A47 Wansford to Sutton Dualling

Appendix 13.2 – Drainage strategy report

ENVIRONMENTAL STATEMENT APPENDICES
Appendix 13.2 – Drainage Strategy Report

Regulation Number:	Regulation 5(2)(a)
Planning Inspectorate Scheme Reference	TR010039
Application Document Reference	TR010039/APP/6.3
BIM Document Reference	HE551494-GTY-HDG-000-RP-CD-00001-C01
Author:	A47 Wansford to Sutton Project Team, Highways England

**DRAINAGE LAYOUT PLAN
SHEET 6 OF 7**

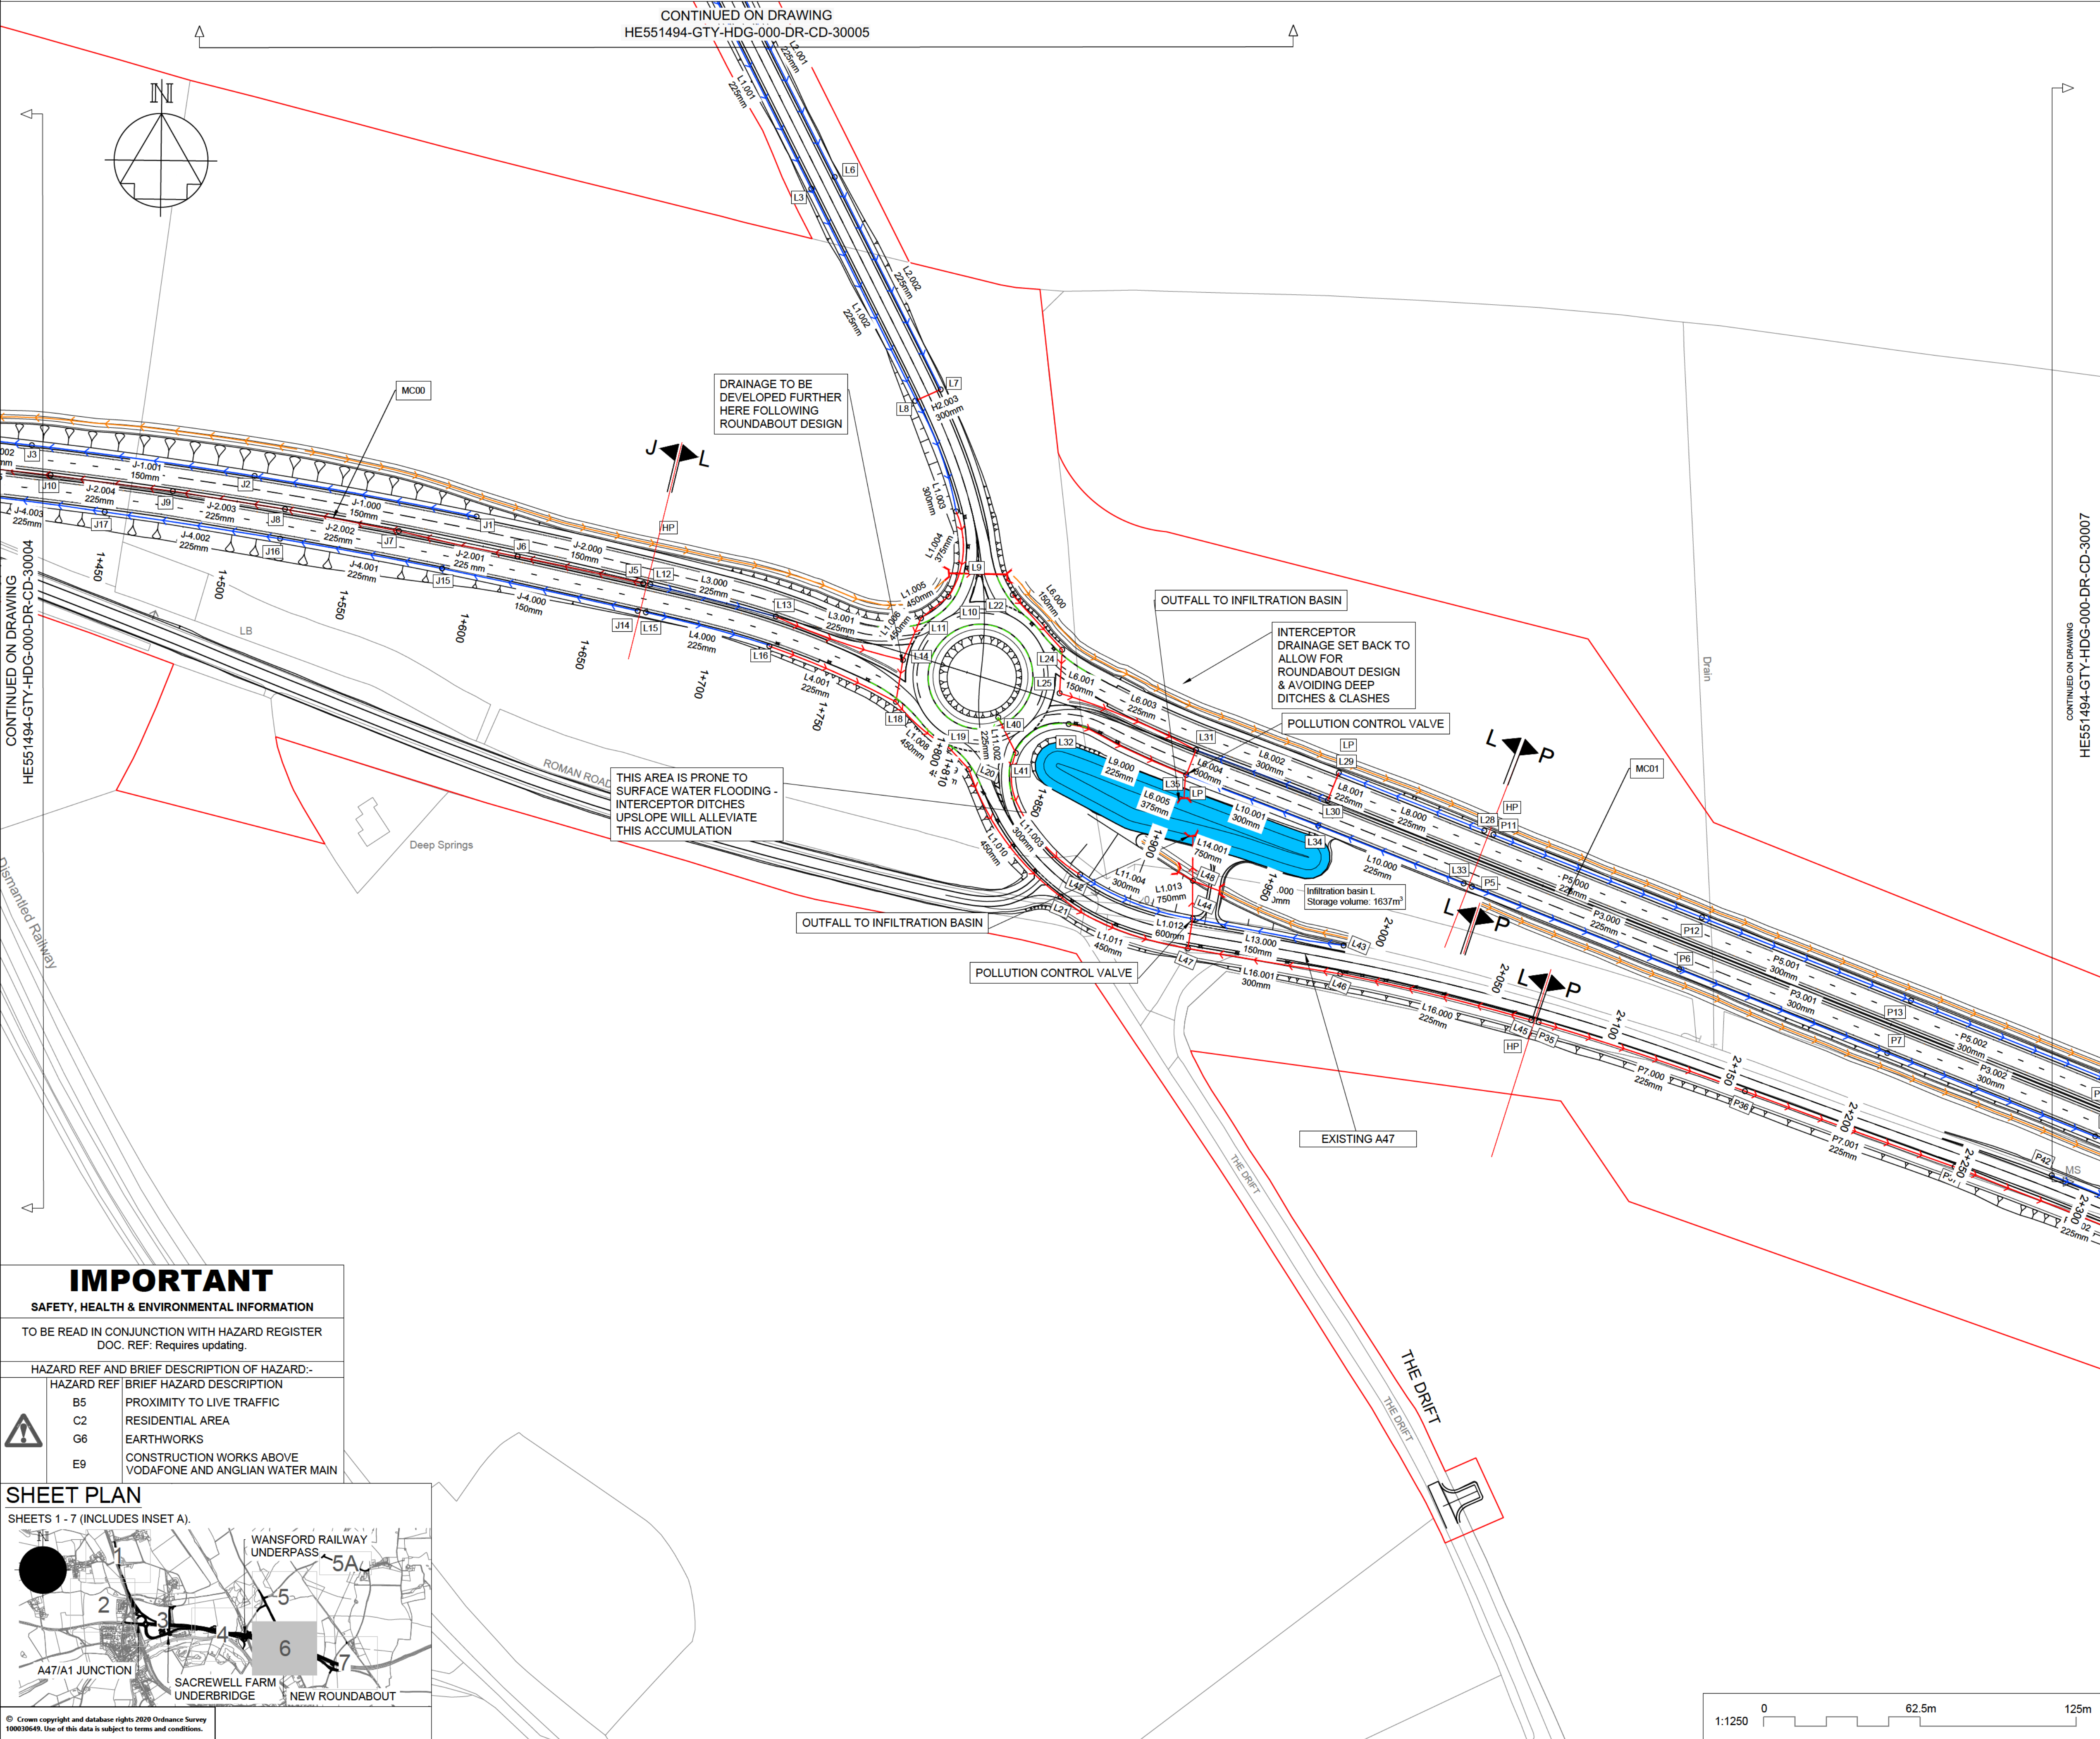
Sheet 6

1. Infiltration basin L - ground investigation information and infiltration test results need to be provided, which should also include the levels of the water table.
2. In relation to the proposed new road north of the roundabout and the associated culvert, if these were intended to be offered for adoption to the Local Highways Authority, then we would recommend that you get in touch with the PCC's Highway Control team regarding this.
3. Network P - we note the drawing references a connection into S11 or to continue along side road, as such we require clarification of what this refers to.
